Agenda Item 3
114 Washington Circle
Additions, Demolition of Existing Garage, New Replacement Garage,
Building Scale Variance

114 Washington Circle

Consideration of a request for approval of a two-story rear and side addition, demolition of the existing detached garage, and construction of a replacement garage. A building scale variance is also requested.

Consideration of a request for approval of the demolition of a single family residence and construction of a replacement residence and attached garage. Approval of a conceptual landscape plan and overall site plan is also requested.

Proposed Site Plan

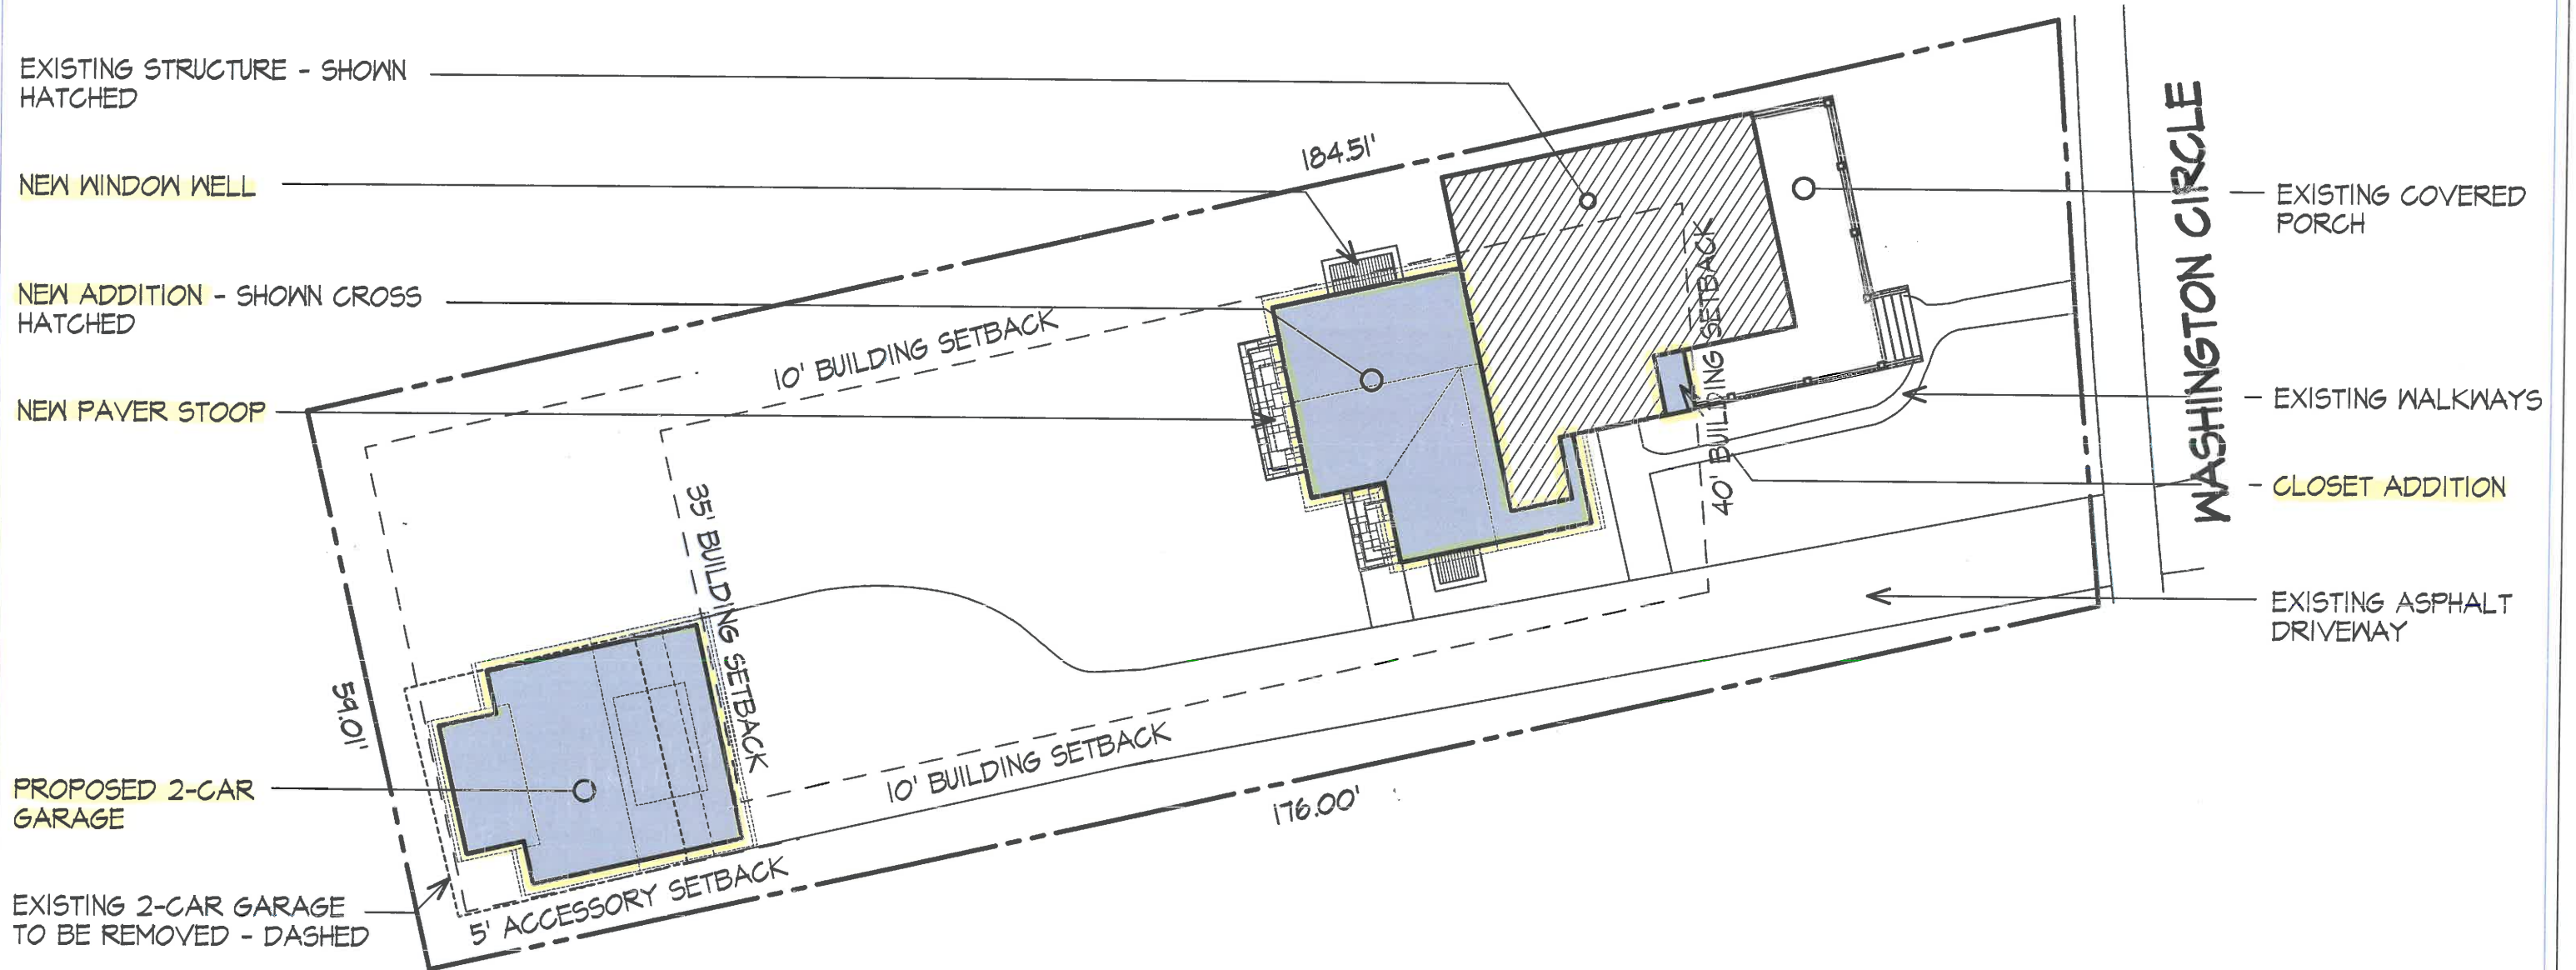
The proposed two-story addition is located mostly behind the existing house on the rear elevation. To avoid encroaching into the side yard setback, the proposed addition is shifted south of the existing home. The existing home partially encroaches into the setback on the north side of the property.

The proposed replacement garage is in the southwest corner of the site, generally in the location of the existing garage, but slightly shifted east in order to comply with zoning setback requirements. The existing driveway and curb cut are not proposed to change.

Landscape Plan

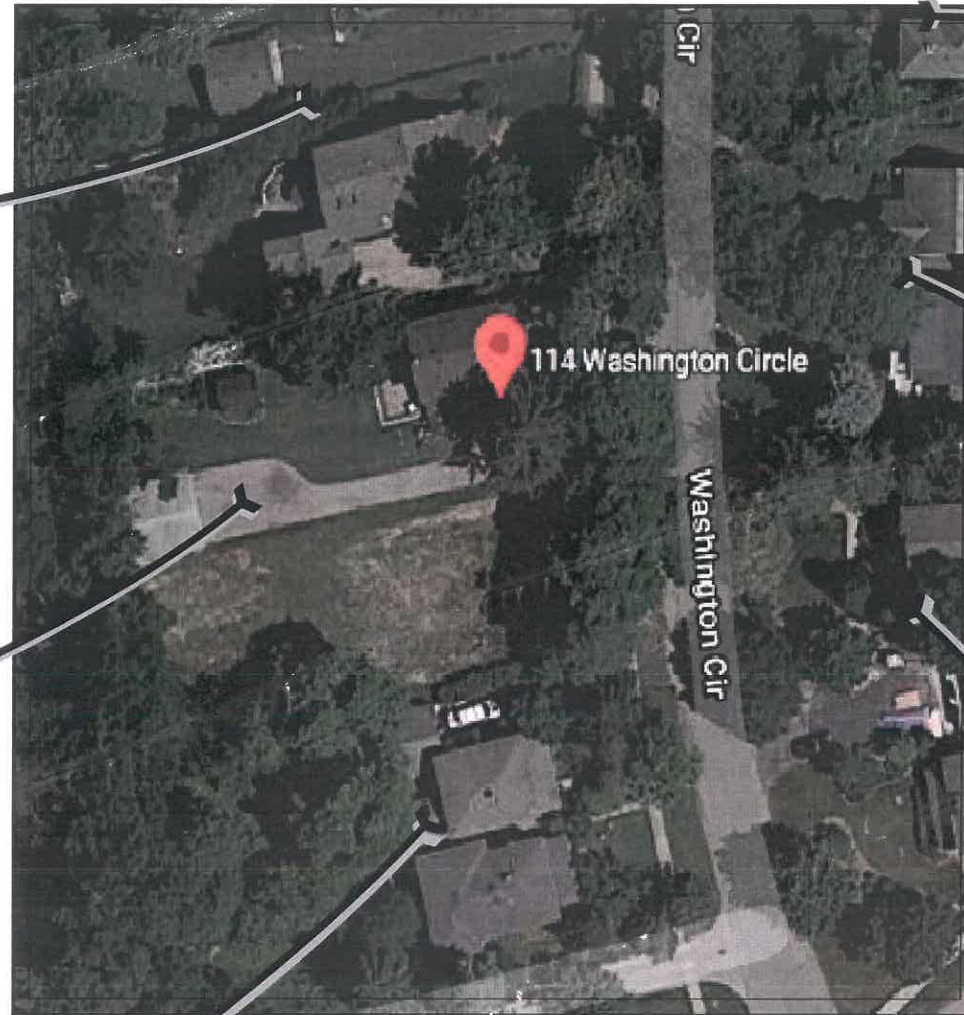
The proposed work is not expected to impact any existing trees on the site. A landscape plan was submitted by the petitioner and is included in the Board's packet. The plan shows the existing landscaping on the property with new plantings around the foundation of the existing home, proposed addition and replacement garage. New plantings are also proposed along the north and south property lines and in the front yard. New plantings include Maple and Redbud trees, a variety of shrubs, grasses and ornamental plantings.

2. A final landscape plan shall be submitted and will be subject to review and approval by the City's Arborist. Particular attention shall be paid to assuring sufficient screening along the property lines either through existing vegetation or, additional plantings if it is determined by the City's Certified Arborist that additional screening can be accommodated to reasonably screen the appearance of the additions and garage.

SITE PLAN OVERLAY

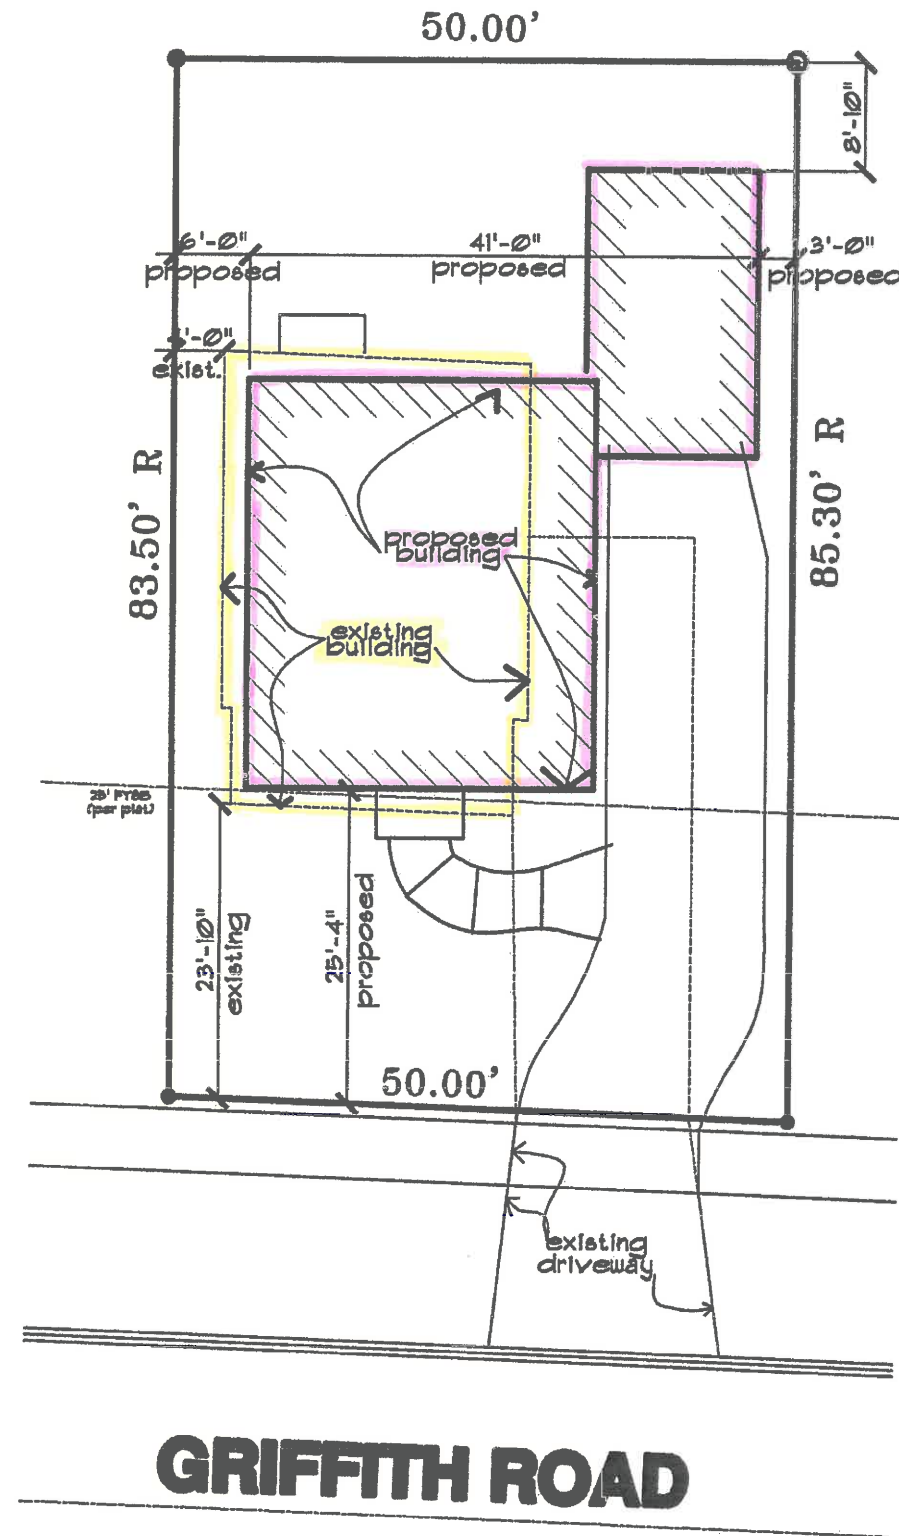
The proposed residence is sited generally in the location of the existing home on the property. A site plan overlay showing the proposed replacement residence in relation to the existing house is included in the Board's packet. The existing home does not have a garage. The proposed replacement residence has an attached garage that is shifted to the rear of the home, toward McKinley Road, consistent with the existing development pattern in the surrounding neighborhood.

The site plan and information submitted by the petitioner shows that the amount of impervious surface on the site will increase from coverage of 41 percent to 54 percent. The increase in impervious surface is mostly due to the larger building footprint with the attached garage and the proposed patio. The building footprint coverage increases from 848 square feet to 1,249 square feet.

1. The plans shall be refined to address the following items if so directed by the Board.
 - a. Incorporate pervious materials into the hardscape plan to reduce the amount of impervious surface on the property.

LANDSCAPING PLAN
SCALE 1" = 15'-0"

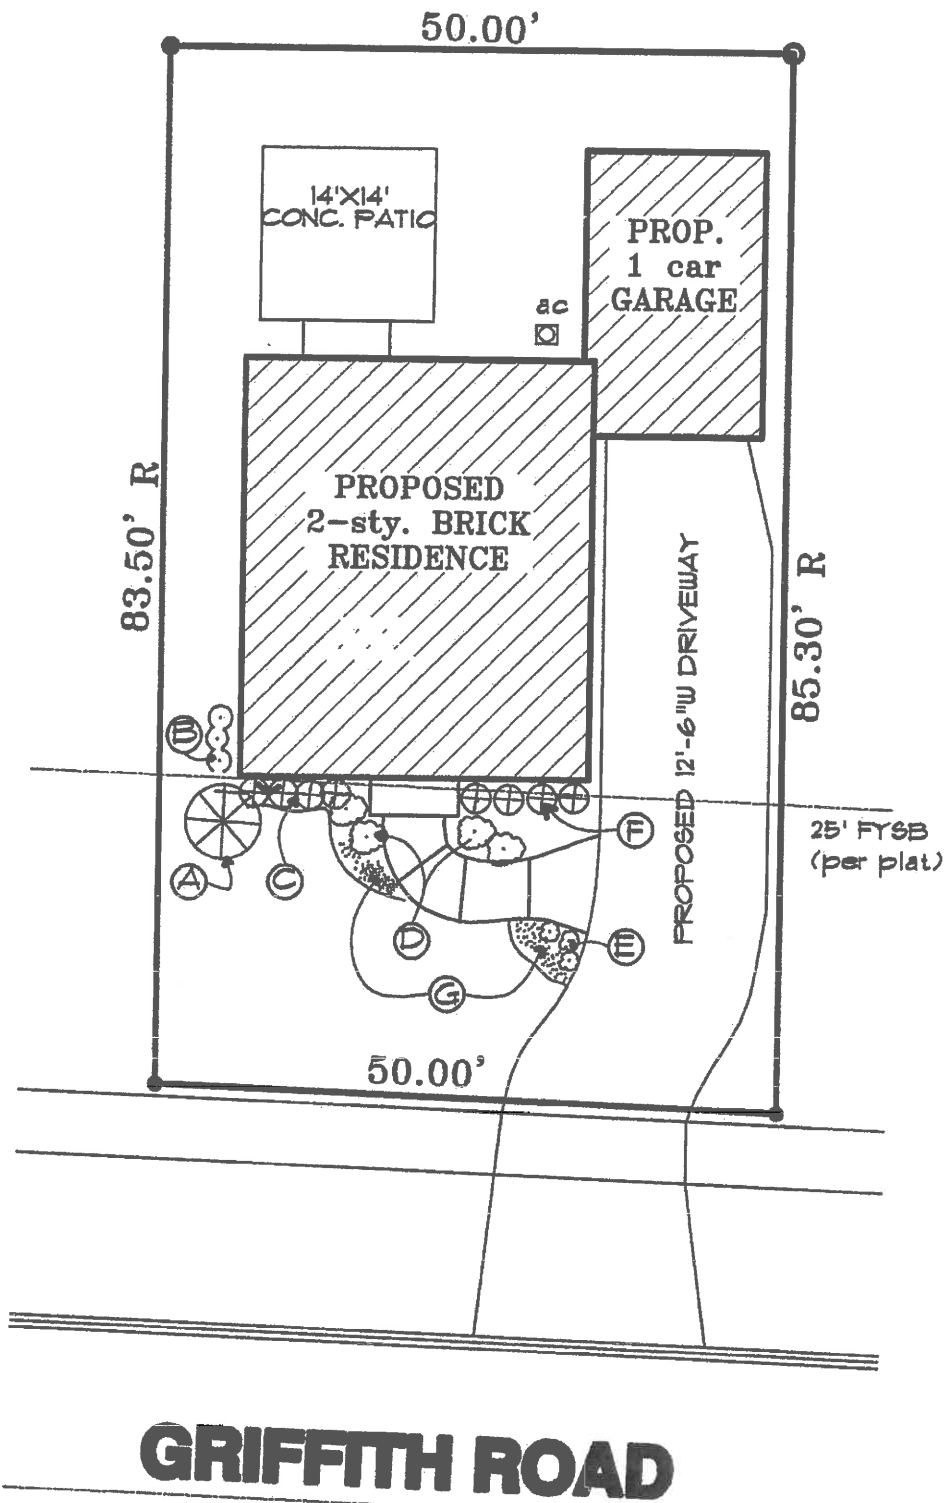
A conceptual landscape plan was provided by the petitioner and is included in the Board's packet. The plan reflects new plantings at the front of the home. The new plantings include Redbud and Dogwood trees, evergreen shrubs and ornamental plantings. Additional shade or evergreen trees are needed to meet the minimum landscape requirements for new residences.

5. Prior to the issuance of a building permit, a detailed, landscape plan shall be submitted and will be subject to review and approval by the City's Certified Arborist. The plan shall, at a minimum, meet the landscaping standards for new residences detailed in the Code and provide for the required 12 replacement inches on site to the extent possible using good forestry practices. If all replacement tree inches cannot be accommodated on the site, the number of remaining inches for which a payment in lieu of planting will be required must be noted on the plan. The full payment in lieu of on site plantings is required prior to the issuance of a Certificate of Occupancy.
